Comments on Docket No. FHWA-2020-0001 National Standards for Traffic Control Devices; the *Manual on Uniform Traffic Control Devices for Streets and Highways*; Revision

Please use this form to provide comments on the Notice of Proposed Amendments for the MUTCD.

MUTCD NUMBER 1-5CODE G94-1

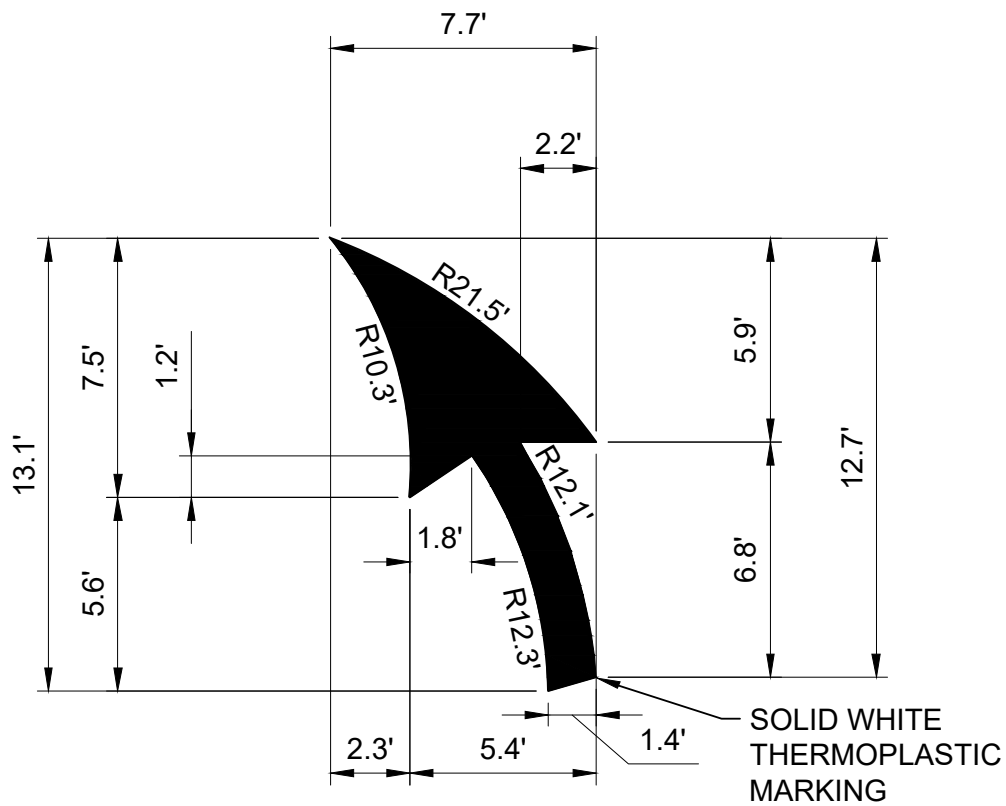
2H.03 (#259)	NO	YES	N/A	I agree with the creation of an Airport Signs section, but I ask for a change in the use of the Airport (I-5) symbol and sign. The Airport (I-5) symbol and sign should be reserved for <u>Commercial Service</u> airports. An alternate symbol, such as the light propeller-driven aircraft used in California's G94-1(CA) sign, should be used for <u>Non-Carrier</u> (general aviation) airports. In urban areas with multiple airports, it is confusing for unfamiliar drivers to have the I-5 symbol to direct them to general aviation airports. I have attached a PDF of the example G94-1(CA) sign.
2L.02 (#296)	YES	N/A	N/A	I agree with the proposed Applications of Changeable Message Signs, specifically that that messages with obscure meaning, references to popular culture, that are intended to be humorous, or otherwise use nonstandard syntax, not be displayed because they can be misunderstood and degrade the overall effectiveness of the sign as an official traffic control device.
